Project	IEEE 802.16 Broadband Wireless Access Working Group < http://ieee802.org/16 >	
Title	Changes on inter-base station messages associated with handover	
Date Submitted	2004-03-05	
Source(s)	Changjae Lee, Kiseon Ryu, Jay Jin LG Electronics, Inc. 533,Hogye-1dong,Dongan-gu, Anyang-shi,Kyongki-do,Korea	Voice: 82-31-450-4387 Fax: 82-31-450-7912 [mailto:cjlee16@lge.com]
Re:	Task Group Review of IEEE802.16e-D1	
Abstract	This document contains suggestions to change the inter-base station messages associated with handover.	
Purpose	This document is submitted for review by 802.16e Working Group members	
Notice	This document has been prepared to assist IEEE 802.16. It is offered as a basis for discussion and is not binding on the contributing individual(s) or organization(s). The material in this document is subject to change in form and content after further study. The contributor(s) reserve(s) the right to add, amend or withdraw material contained herein.

Changes on Inter-base station messages

The following figure-“HO process by MSS request” shows what the proposal is applied.

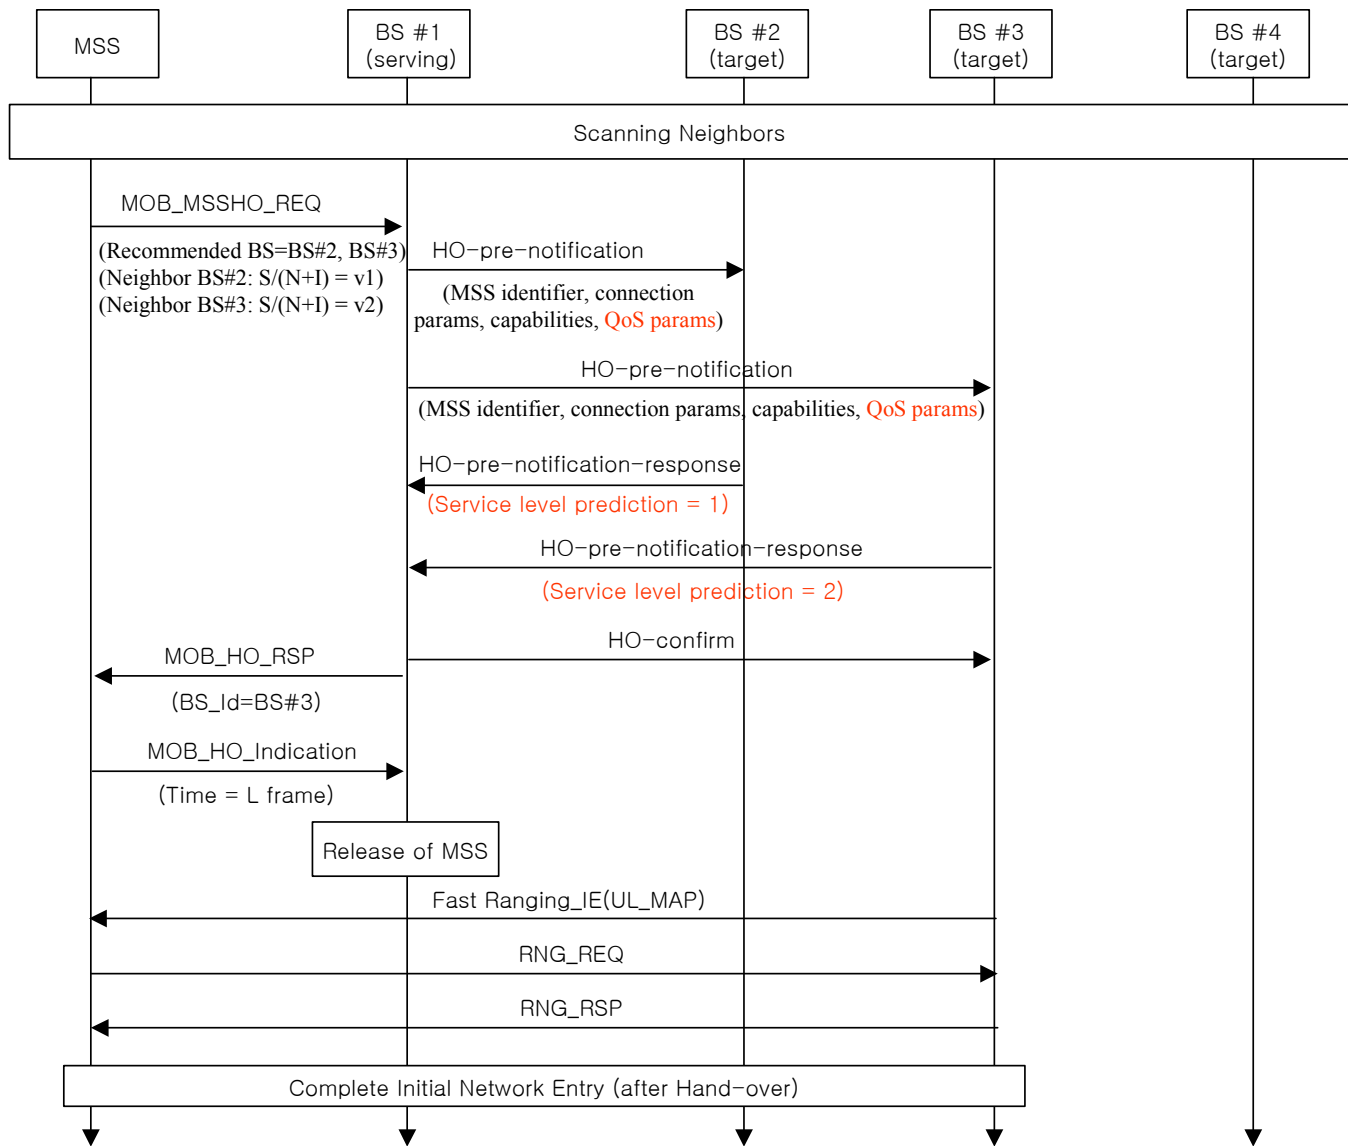
But, several inter-base station messages (HO-pre-notification, HO-pre-notification-response and HO-confirm) don't include the concept of multiple Service Flows in their parameters.

Currently, “Required BW/QoS” in HO-pre-notification message and “BW/QoS Estimated” in HO-pre-notification-response message represent QoS level of only one Service Flow.

Therefore, problems may exist as followings:

1. The Serving BS does not have any information to choose specific Service Flow that should be guaranteed for minimum bandwidth among multiple Service Flows.
2. After receiving HO-pre-notification-response message from one or more the potential Target BS, Serving BS shall send MOB_BSHO_RSP message with Service Level Prediction for potential Target BS to the MSS.

But, because HO-pre-notification-response message has a parameter for only one Service Flow(Estimated BW/QoS) and ACK/NACK indication, it is not sufficient information to decide the Service Level Prediction in MOB_BSHO_RSP message.

For the purpose to solve the above problems, we propose that QoS parameters (Network Service Information Element) which can include all Active Service Flow in the HO-pre-notification message instead of Required BW/QoS parameters.

We also propose the Service Level Prediction parameter in HO-pre-notification-response instead of ACK/NACK indication.
